**City of Portland, Maine - Building or Use Permit Application**  
 389 Congress Street, 04101 Tel: (207) 874-8703, Fax: (207) 874-8716

**CITY OF PORTLAND, ME  
BOCA 1999 Plan Review Record  
One and Two Family Dwelling**

BUILDING PERMIT REPORT

CHECK-LIST AGAINST ZONING ORDINANCE

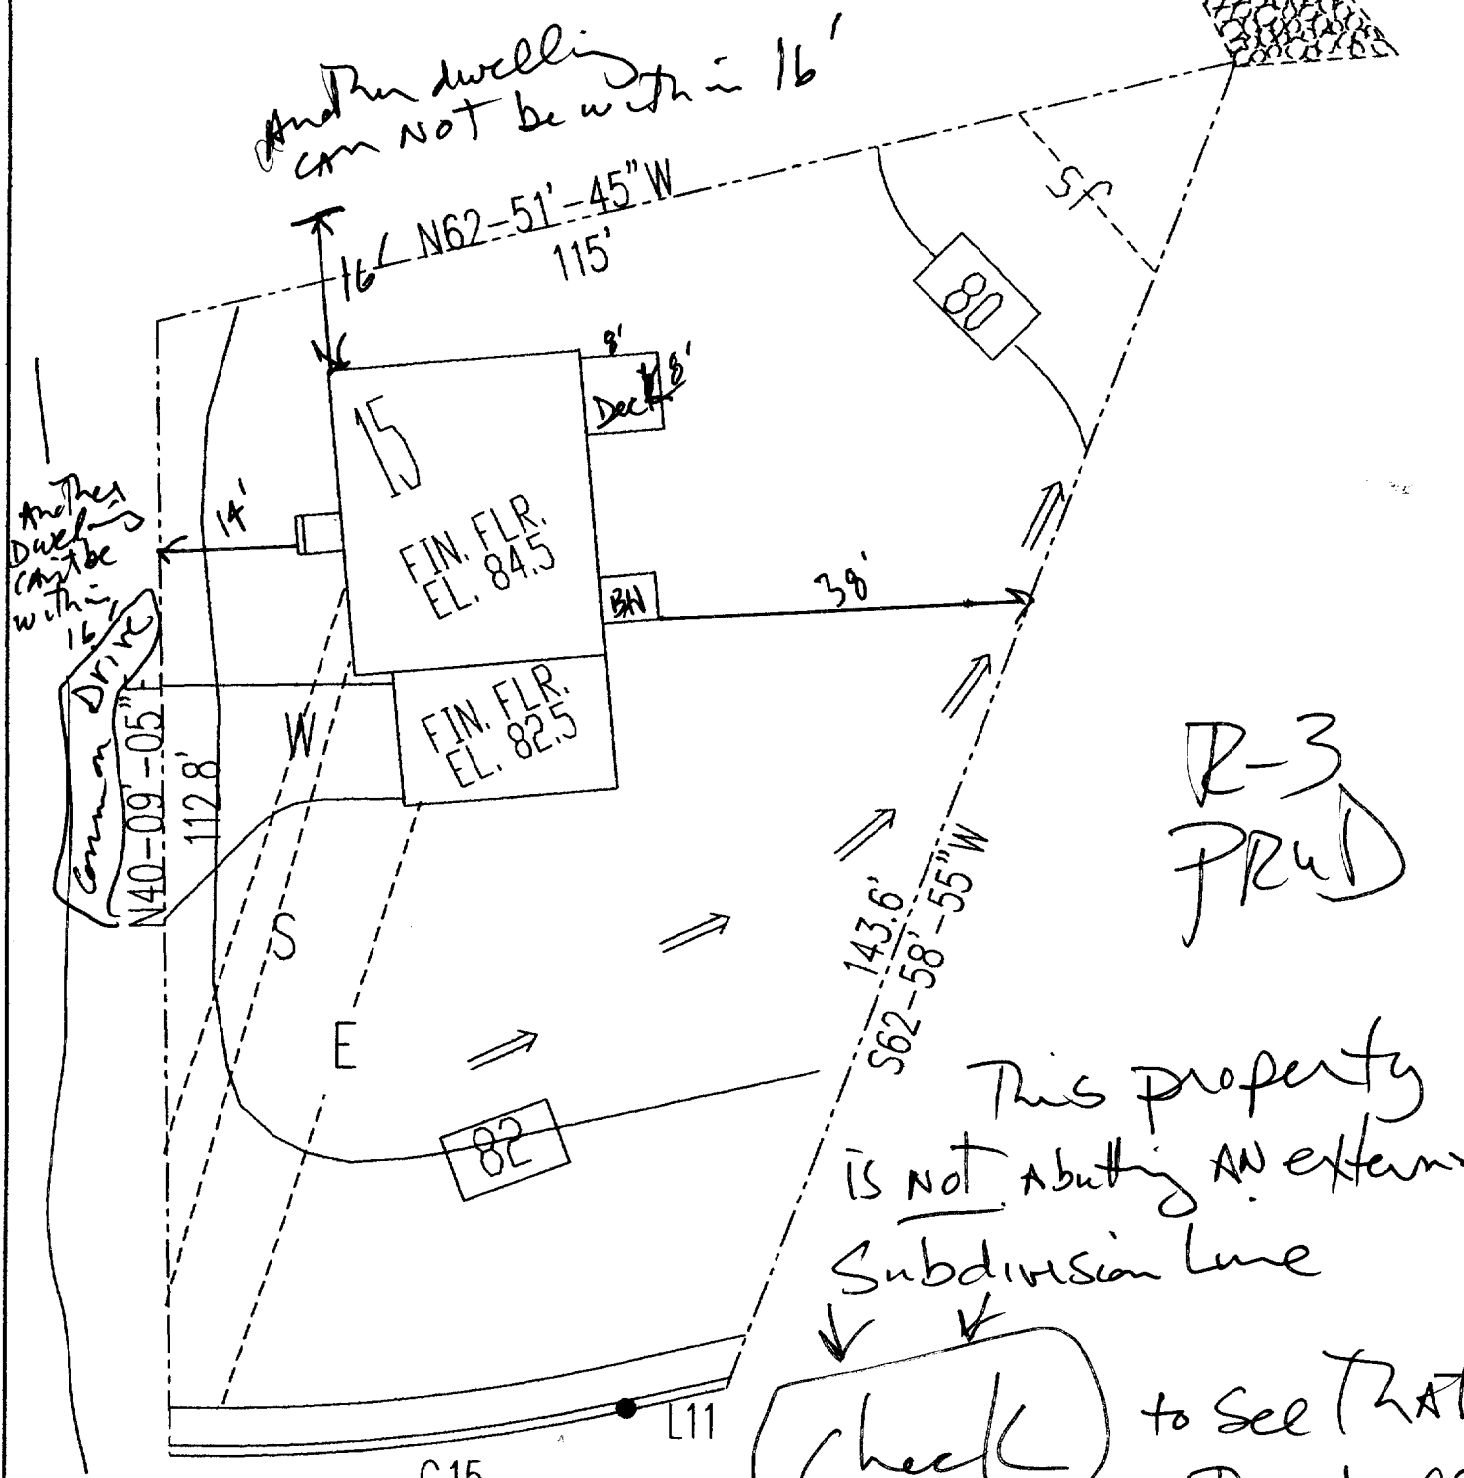
Lot Street Frontage - 1 min. setback from external subdivision property lines: 25' req - NOT A butly the external sub. line

Rear Yard - 2 min. distance between detached PRUD dwelling units - 16' req - NONE show that close  
CEO be sure to check

Projections - 3 Recreation Areas shall be at least 25' from dwelling uses - 25' + shown  
front porch - 8'x8' rear back head

Another dwelling  
can not be within 16'

Another  
Dwell  
can't be  
within  
16'

This property  
is not abutting an external  
Subdivision line

Check to see that  
No other dwellings  
are within 16' of  
This proposed  
Structure

KTO BUILDERS	
PROJECT : COPLEY WOODS	
LOT # 15	DATE 5/31/01
SCALE 1"=20'	CBL 4 13 B 15

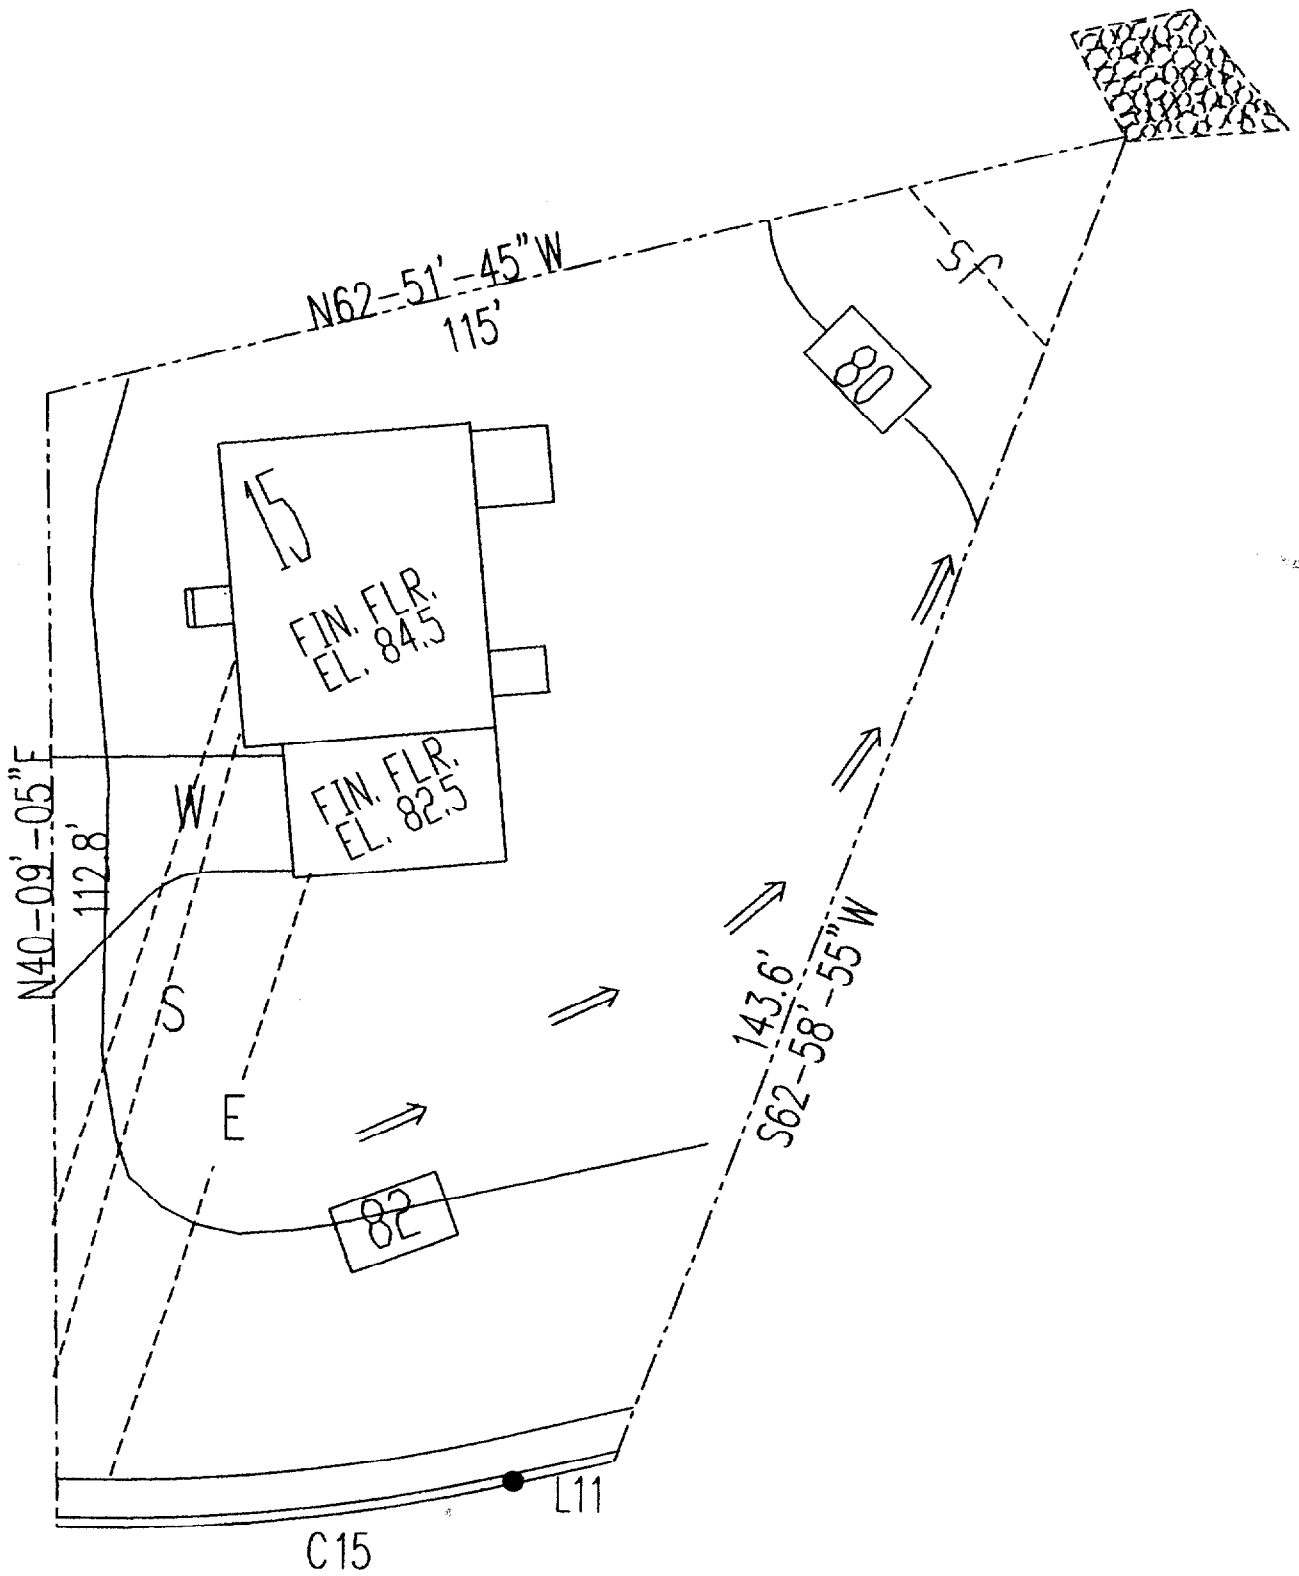
- 1 This permit is being approved on the basis of plans submitted. Any deviations shall require a separate approval before starting that work.
- 2 Separate permits shall be required for future decks, sheds, pools, and/or garage.
- 3 There shall be no other building closer than 16 feet to this structure.
- 4 You are showing an 8' x8' deck on the rear of this structure and a rear bulkhead as part of your approved plans.
